CERTIFICATE OF APPROPRIATENESS

**RE: Application Number 20-6981; 489 Henry; Cass-Henry Historic District
Project Scope: Rehabilitate Apartment Building**

RE: 489 Henry Street—The Berwin Apartments

Sheet
1A101

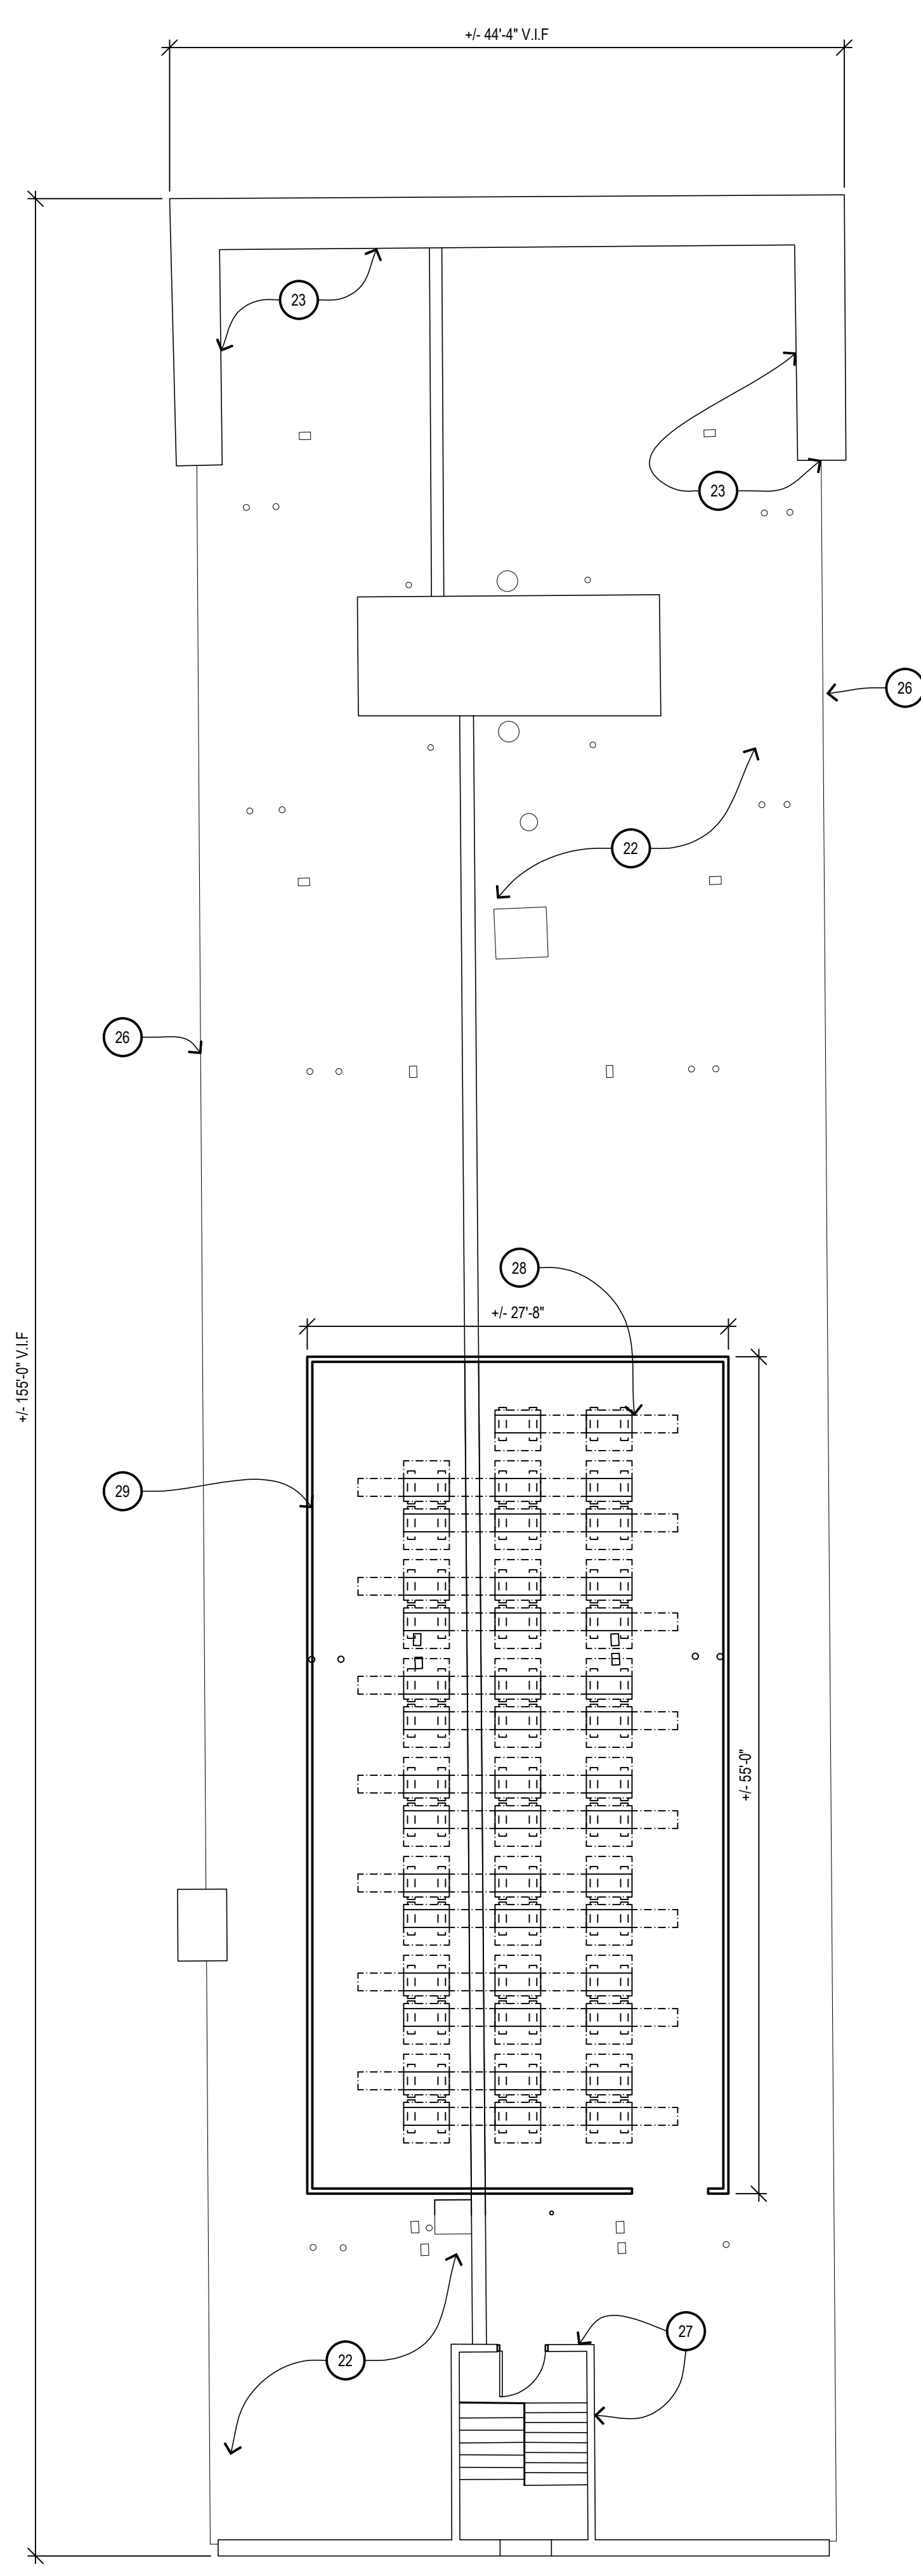
And as per the submitted documents, specifically, drawings 1A101, 1A102 (floor/roof plans) and 1A401, 1A401.1, 1A402, 1A402.1 (elevations).

- Staff review of the submitted construction drawings will include the identification of specific standards concerning repair and/or replacement of deteriorated character-defining features, and related standards concerning the qualifications of historic preservation contractors retained to perform the work.
- Staff review of the submitted construction drawings to specifically include review of specifications/cut sheets for lighting, windows, doors, ADA lifts, signage, paint removal, color choices, and other exterior elements/selections not yet finalized, with staff authority to approve if per the Secretary of the Interior's Standards, the district's Elements of Design, and otherwise consistent with Commission intent and guidelines.
- The historic name of the building, set in stone above the entryway, be preserved and remain visible.

Sheet
1A102

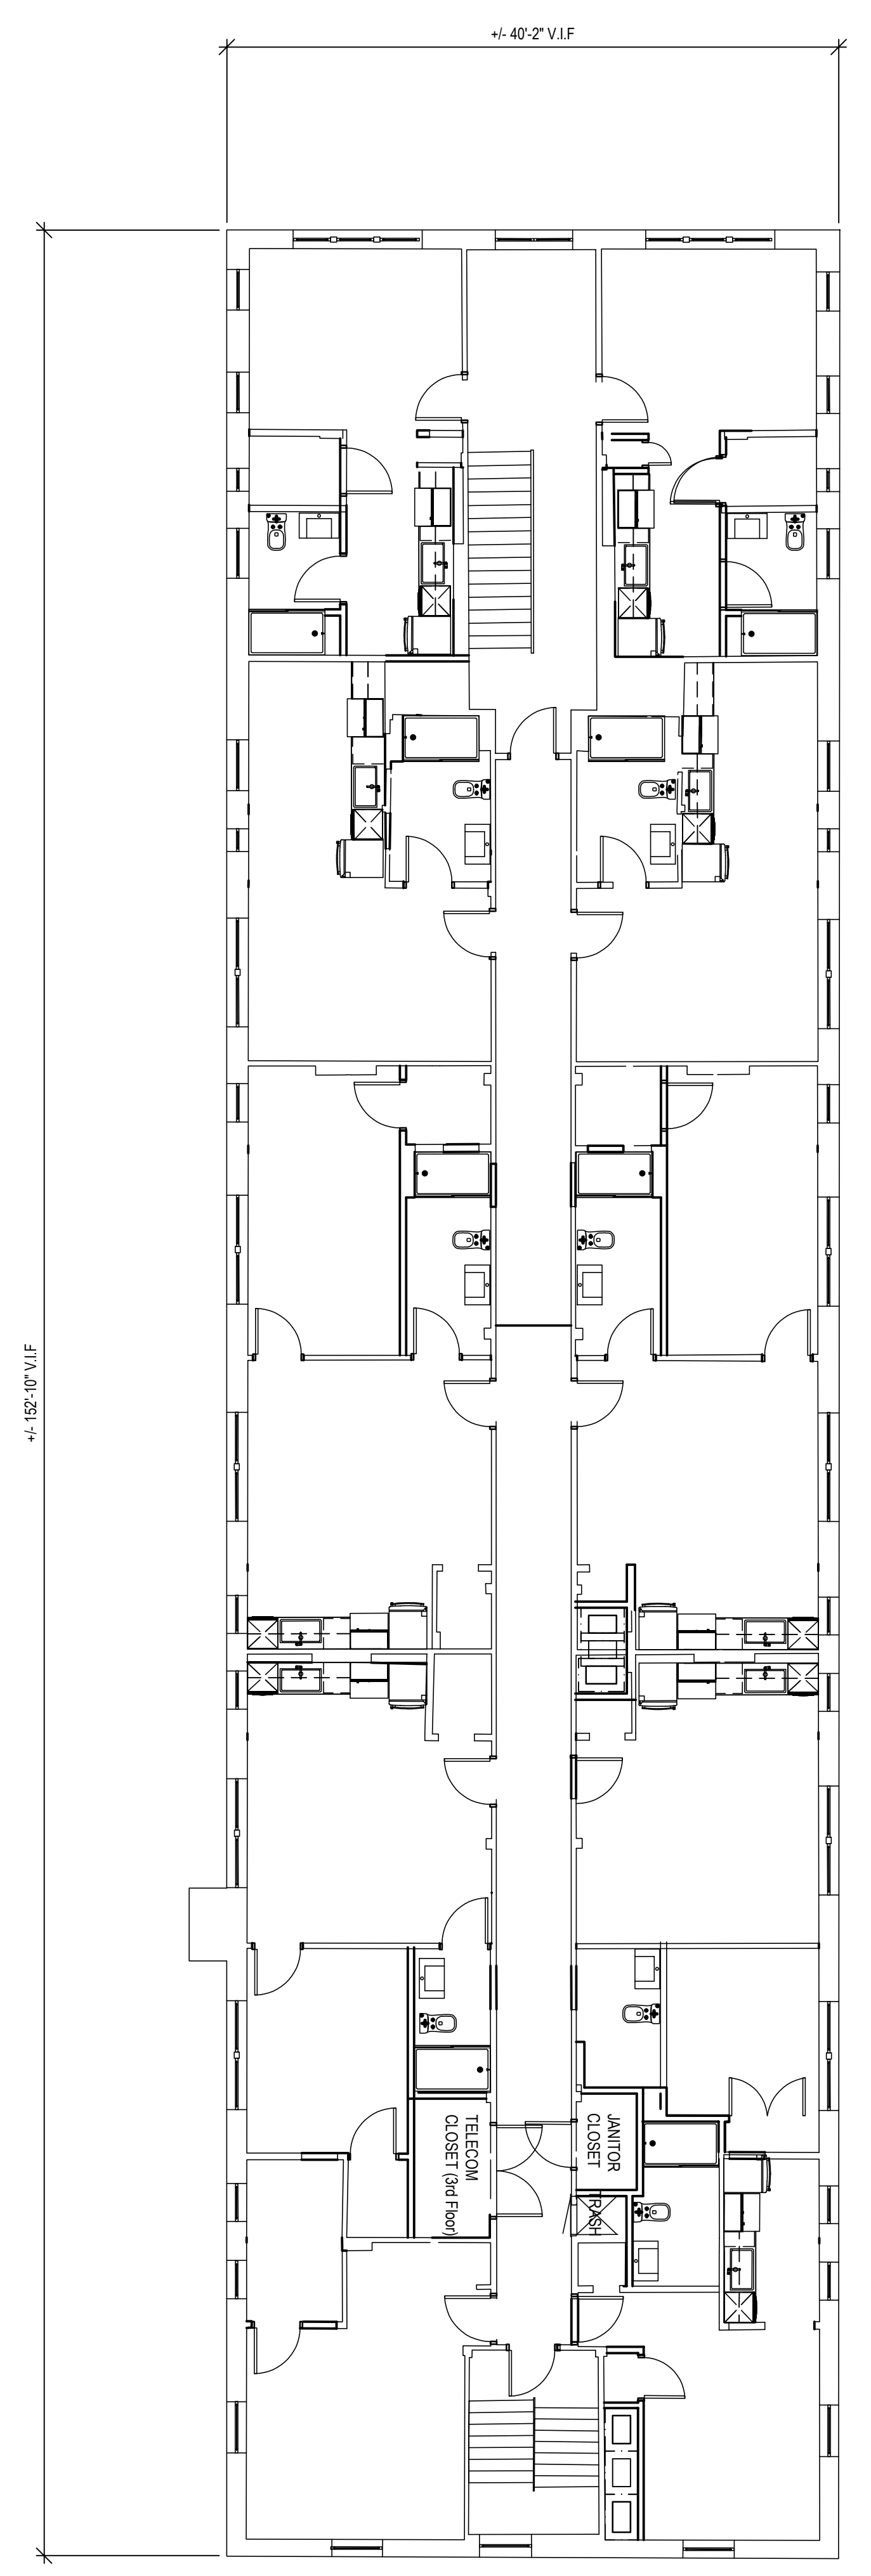
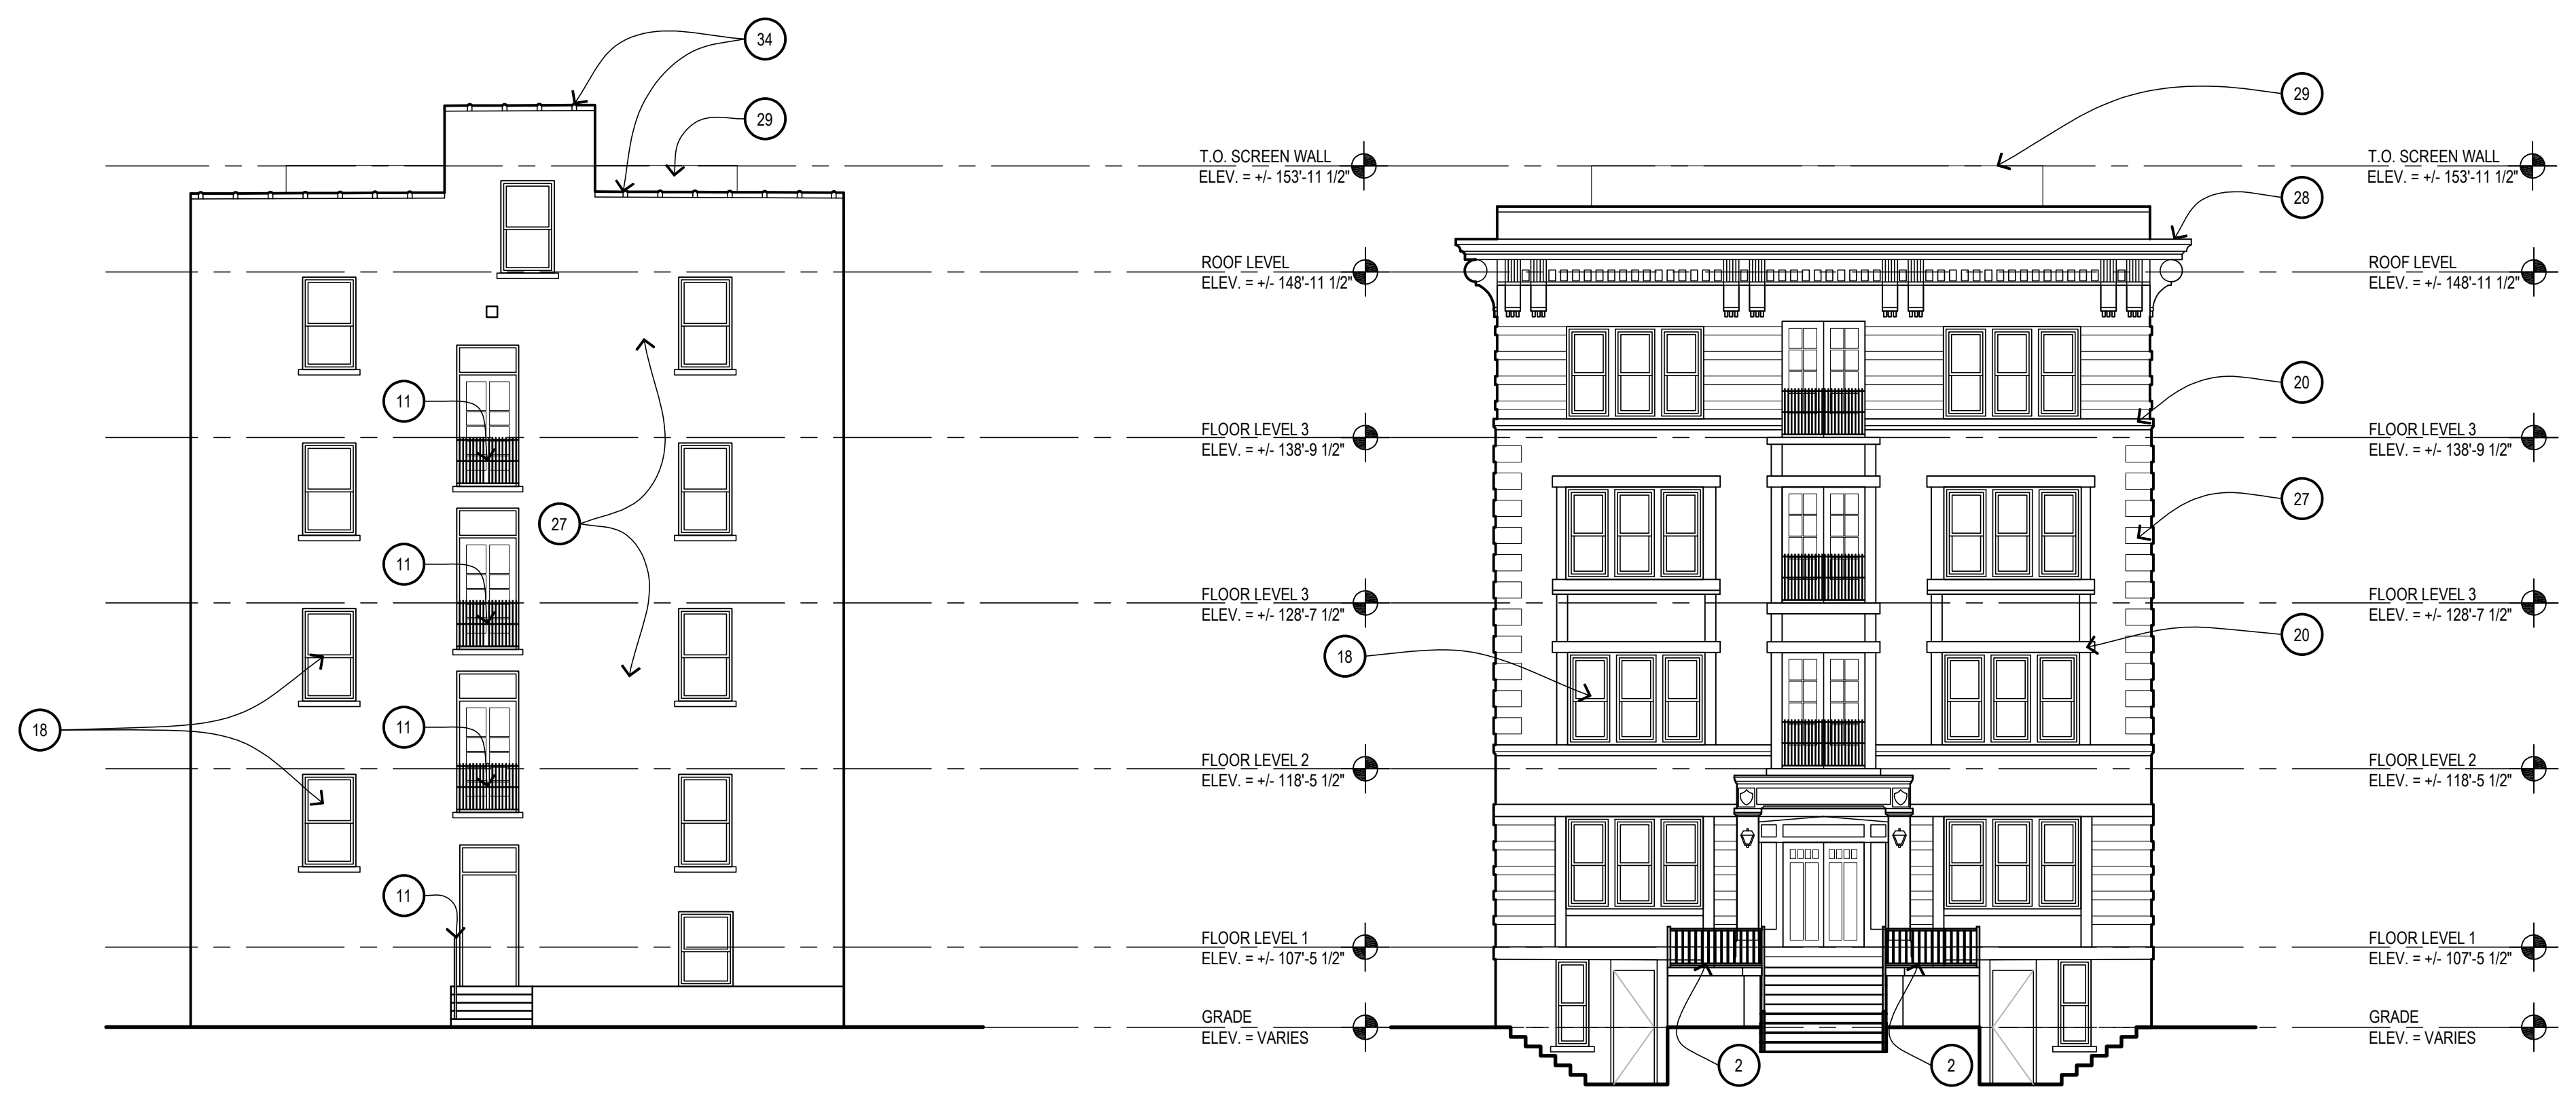
- *Current poor condition membrane roof to be removed and replaced with a new EPDM roof*
- *Small condenser farm will be added to the rear center of the roof and screened with an approximately 5' tall metal roof screen in a "Dove Grey" color*
